Access Compliance Report Public Rights-of-Way (Curb Ramps)

Main Street: LURLINE_LN Cross Street: BULLARD_LN Location: E

ADA ID: RPAT211011100845 Ramp Type: Type 1 - Perpendicular Diagonal Initial Pass/Fail: Pass Overall Compliance: No Severity Score: 22

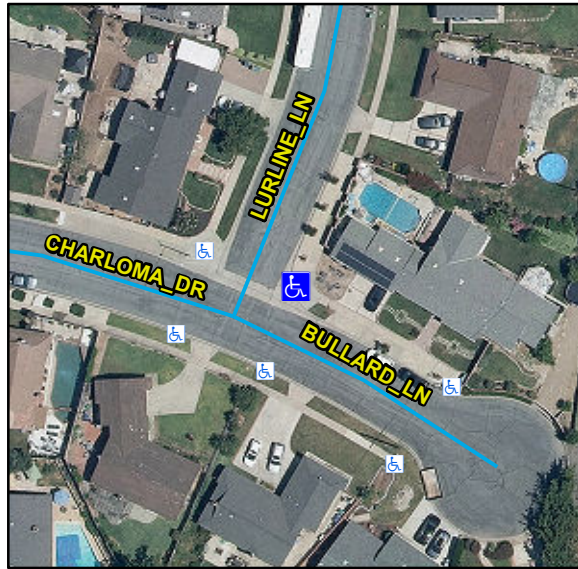
R304.2.2, R204.3, R304.2.1, R304.2.2-Perp, R304.3.2-Para, R304.5.3, R304.2.3, R305, STD 1115

Compliance	Description	Data	Compliance	Description	Data
N/A	Ramp Length (in)	131	N/A	Flare Type LT	
Yes	Ramp Width (in)	54			Sloped
Yes	Ramp Run Slope (%)	7.8	No	Flare Slope LT (%)	10.8
Yes	Ramp Cross Slope (%)	3.7	N/A	Flare Traversable LT	Yes
N/A	Landing Present	No	N/A	Flare Type RT	
N/A	Landing Length (in)	N/A			Sloped
No	Landing Width (in)	N/A	Yes	Flare Slope RT (%)	2
No	Landing Run Slope (%)	N/A	N/A	Flare Traversable RT	Yes
No	Landing Cross Slope (%)	N/A	No	DWS Provided	No
N/A	Landing Movement Obstructed?	Yes	N/A	DWS Contrast	N/A
	Landing Movement Type	Wall	N/A	DWS Length (in)	N/A
N/A	Landing Shared	N/A	N/A	DWS Full Width	N/A
N/A	Clear Space	Yes	N/A	DWS Offset Left (in)	N/A
N/A	Clear Space To Crosswalk (in)	48	N/A	DWS Offset Right (in)	N/A
N/A	Marked Crosswalk 1	No	N/A	Marked Crosswalk 2	No
	Crossing 1 Direction	NW		Crossing 2 Direction	SW
	Marked Crosswalk 1 Width (in)	N/A		Marked Crosswalk 2 Width (in)	N/A

N/A	Ramp Inside Crosswalk 1	N/A	Yes	Ramp Inside Crosswalk 2	N/A
	Crossing 1 Slope (%)	4.3		Crossing 2 Slope (%)	4.6
	Crossing 1 Cross Slope (%)	5.4		Crossing 2 Cross Slope (%)	2
Yes	Gutter Ponding	No	No	Curb Slope	9.4
Yes	Gutter Lip Height (in)	0		Road Run Slope (%)	3.9
Yes	Gutter Run Slope (%)	1.4		Road Cross Slope (%)	0.2
No	Gutter Cross Slope (%)	4.5			
Yes	Overall Surface Condition: Acceptable		No	Perp Joint Present	No
	Cross Gutter Present?	Yes		Spandrel Present?	Yes
	Replace Cross Gutter?	No		Replace Spandrel?	No

Remove & Replace Curb Ramp With Two New Directional Ramps or Equivalent. Remove & Replace Gutter.
